DATE: August 21, 2013

SUBJECT: Addendum No. 1
U.S. 50/Silva Valley Interchange
PW 12-30647, CIP No. 71328

Dist	COUNTY	ROUTE	POST MILES TOTAL PROJECT	SHEET No.	TOTAL SHEETS
03	ED	50	1.02/R2.40	179	371

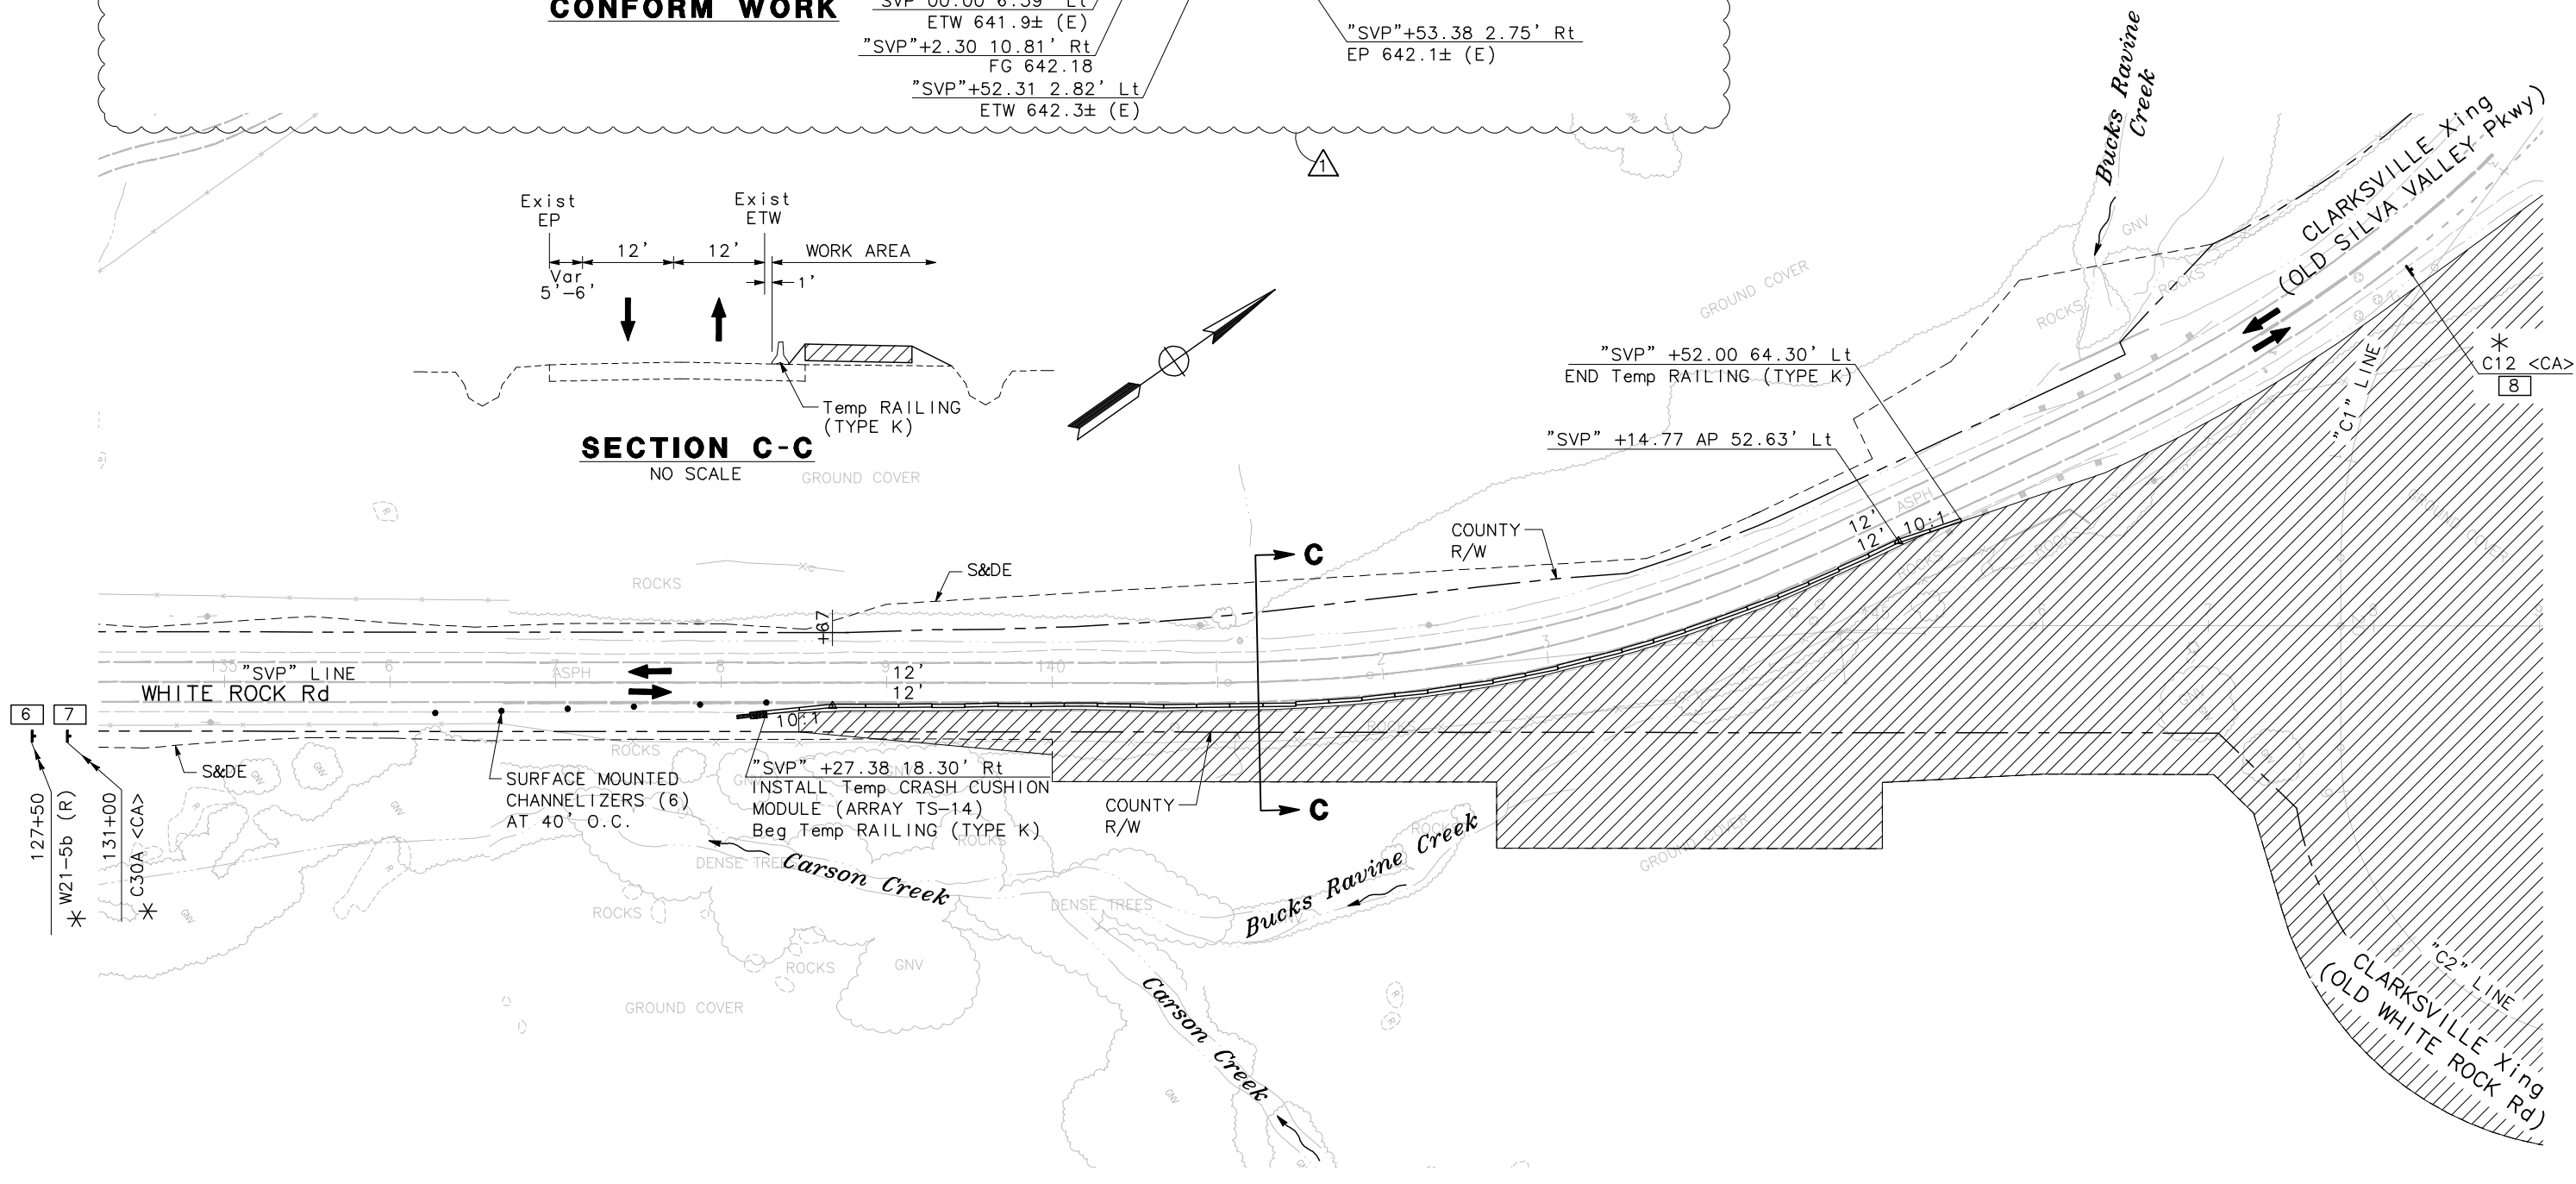
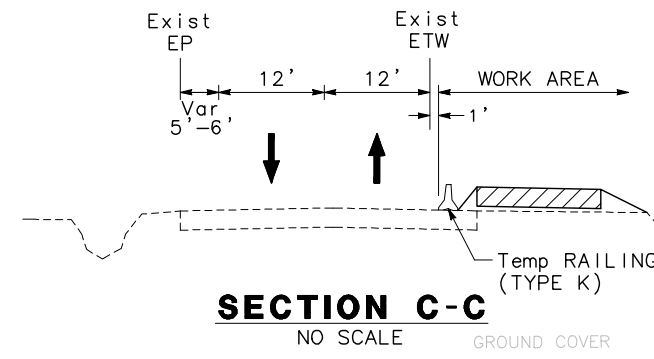
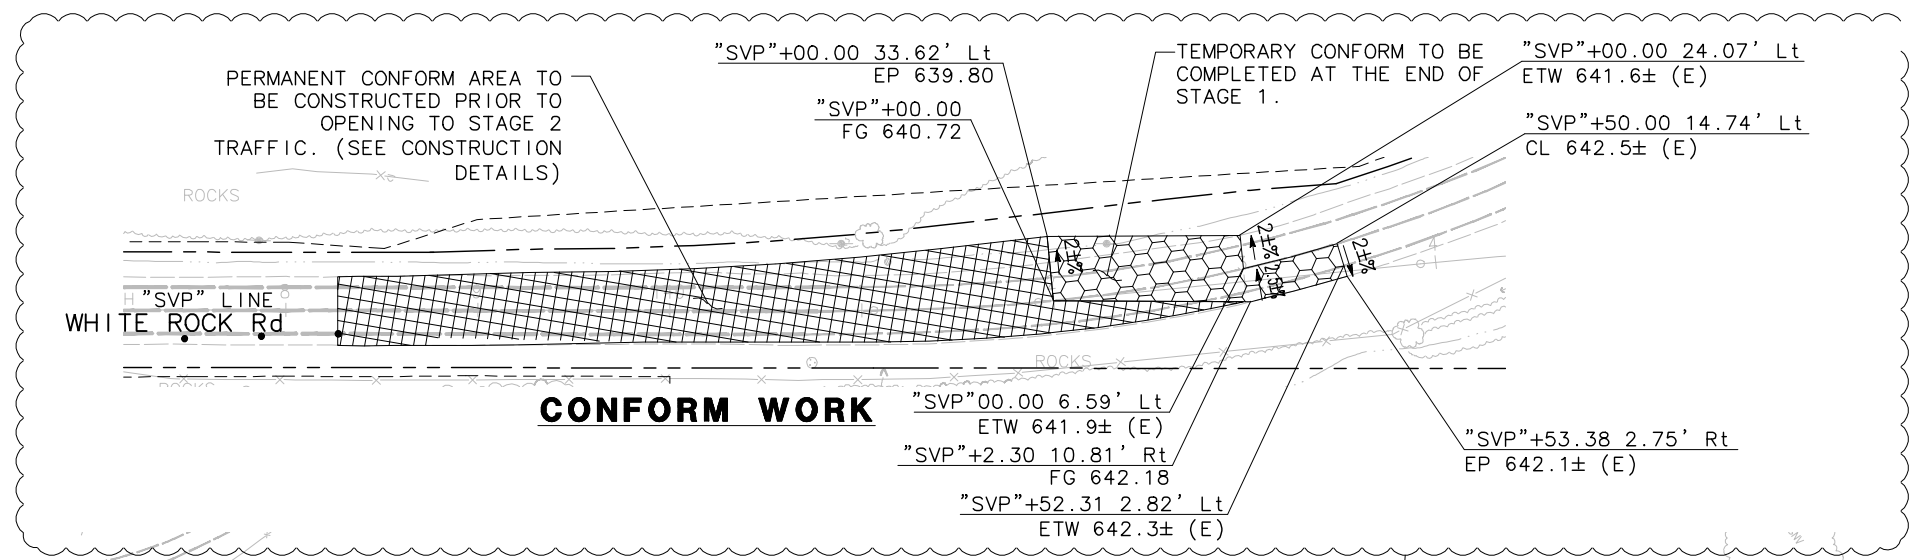
1. 22.	Plan sheets 179 and 180	Bidders are instructed to replace Plan sheets 179 and 180 with revised Plan sheets 179 and 180 attached to this Addendum.

1	08-19-2013	ADDED CONFORM DETAIL	JMN	DWM
MARK	DATE	DESCRIPTIONS	BY	CH'D
REVISIONS

Dist	COUNTY	ROUTE	POST MILES TOTAL PROJECT	SHEET No.	TOTAL SHEETS
03	ED	50	1.02/R2.40	180	371

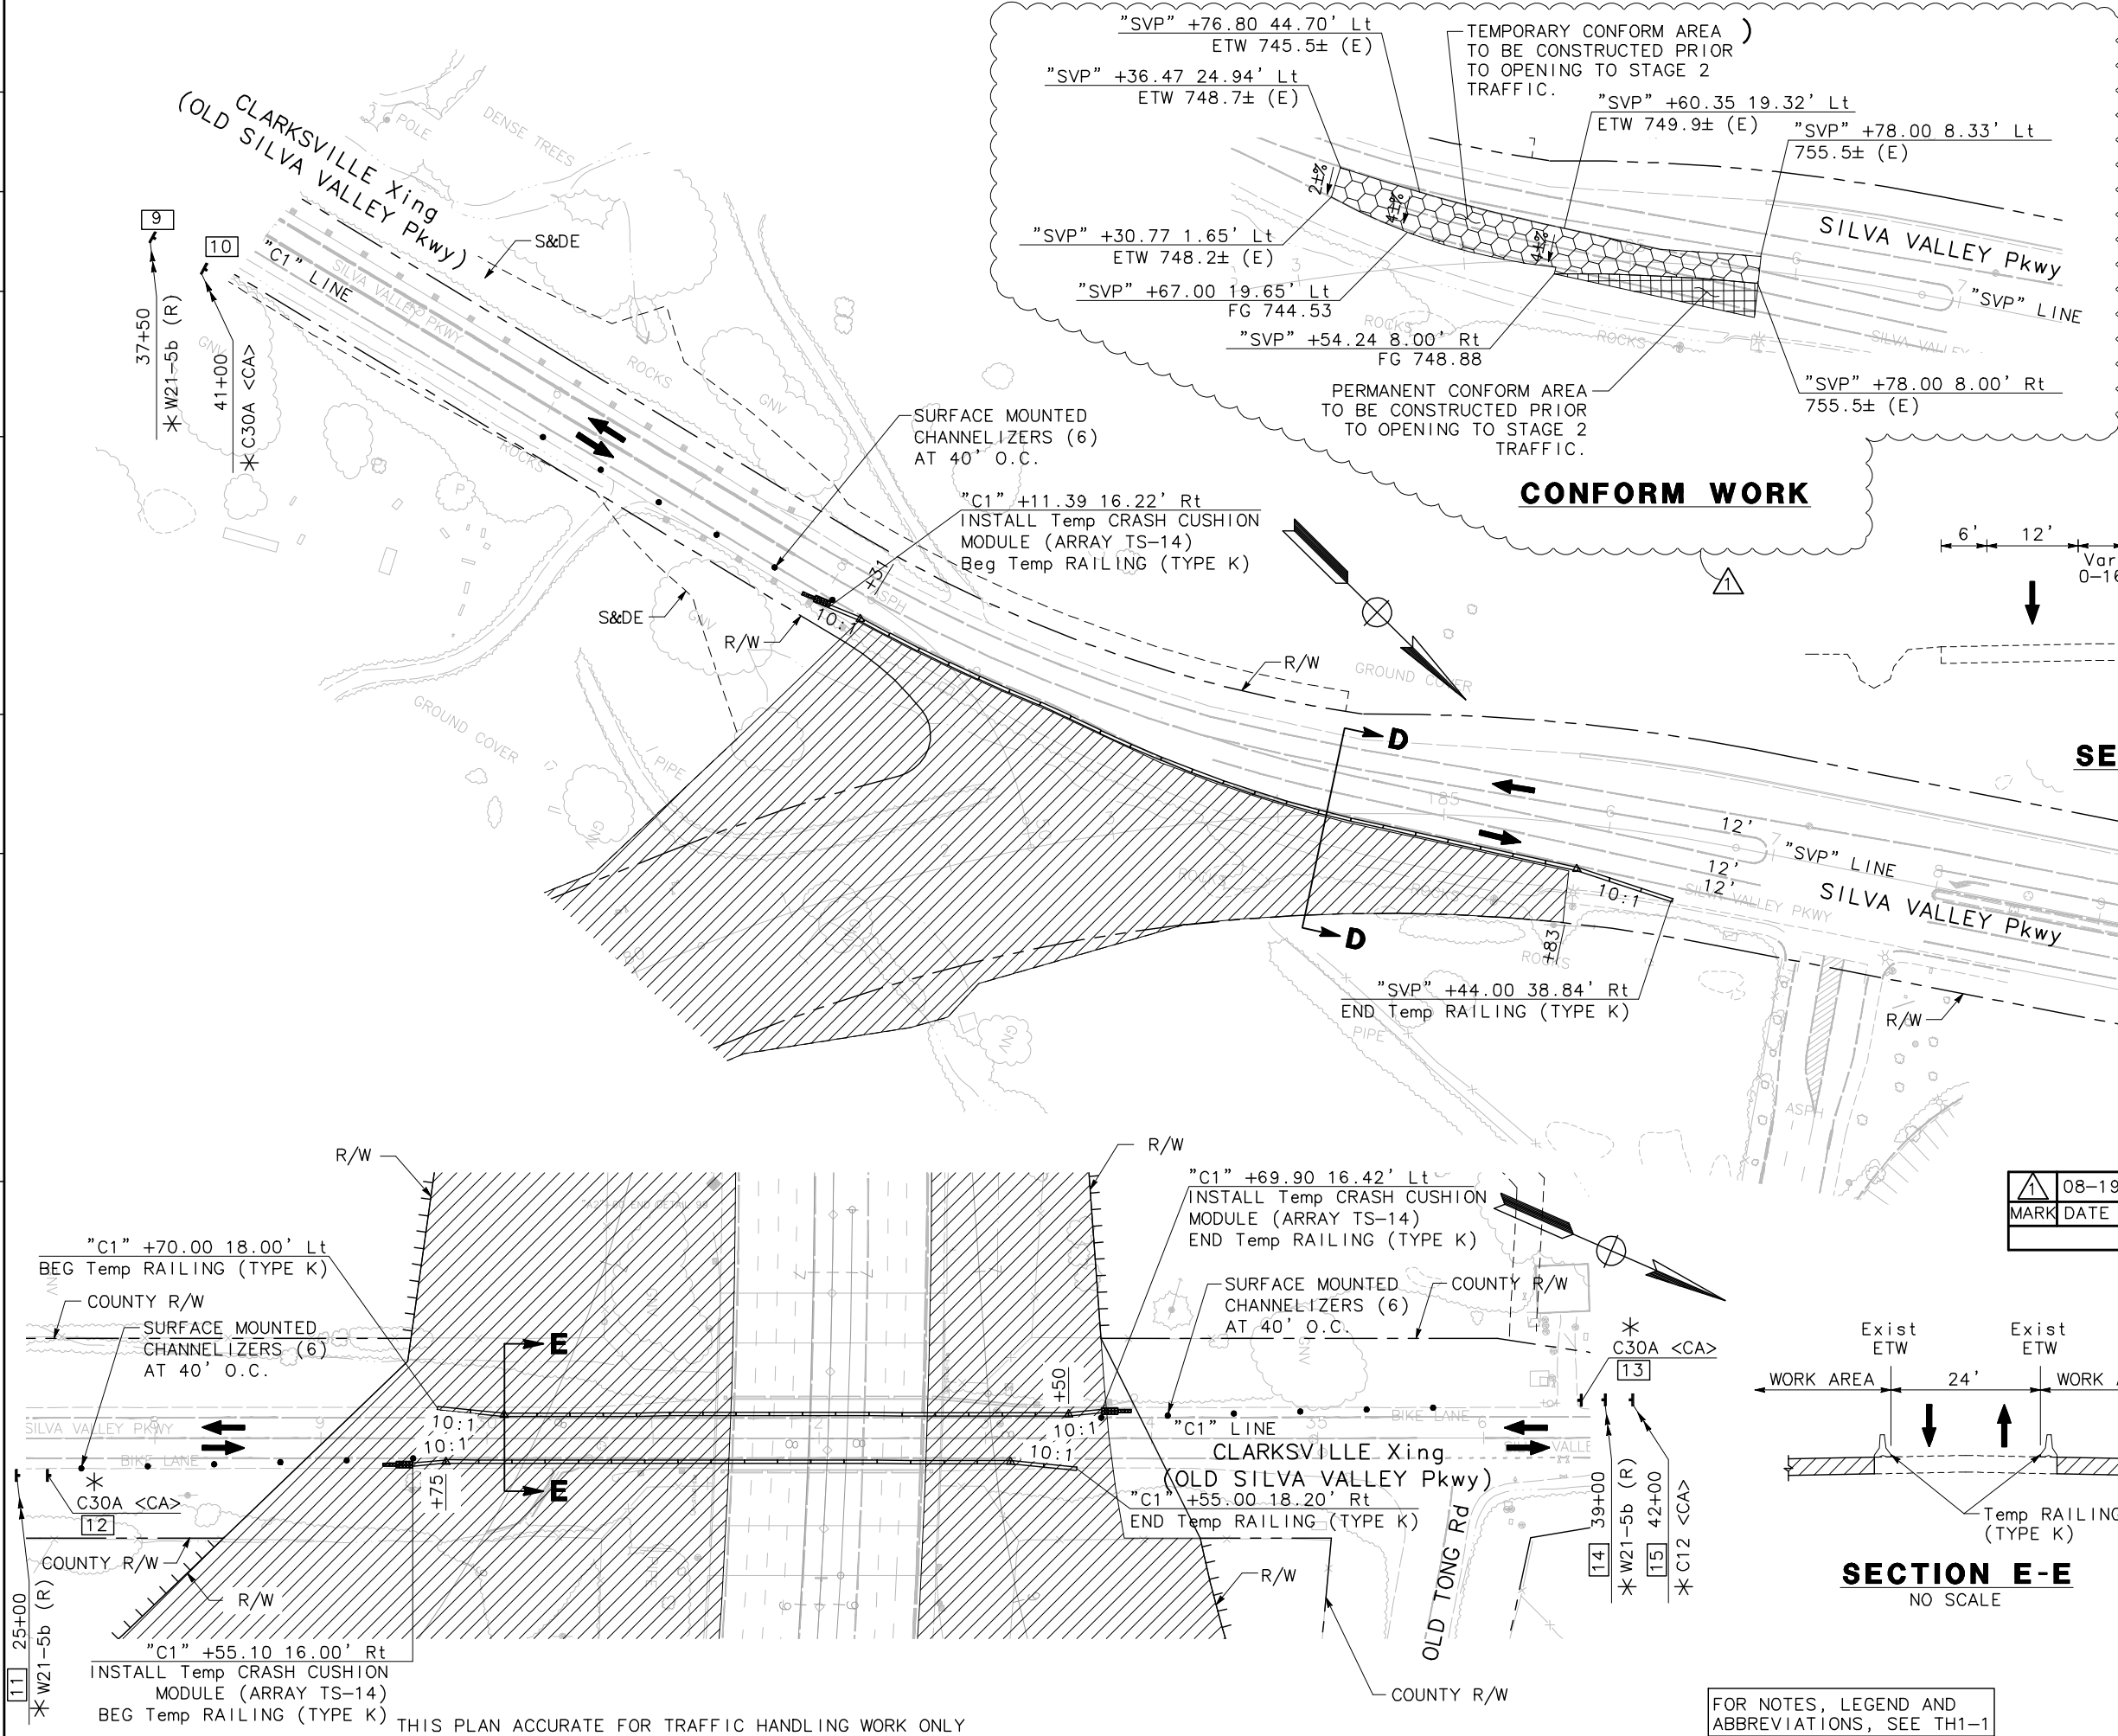
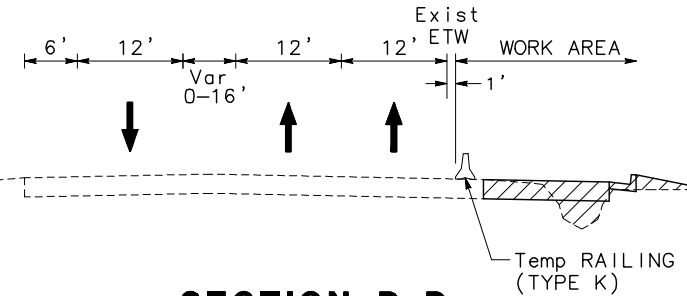
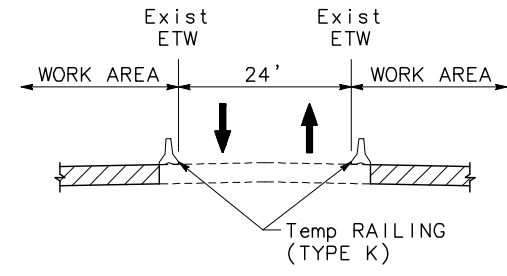
08-19-2013	ADDED CONFORM DETAIL	JMN	DWM
MARK	DATE	DESCRIPTIONS	BY
REVISIONS
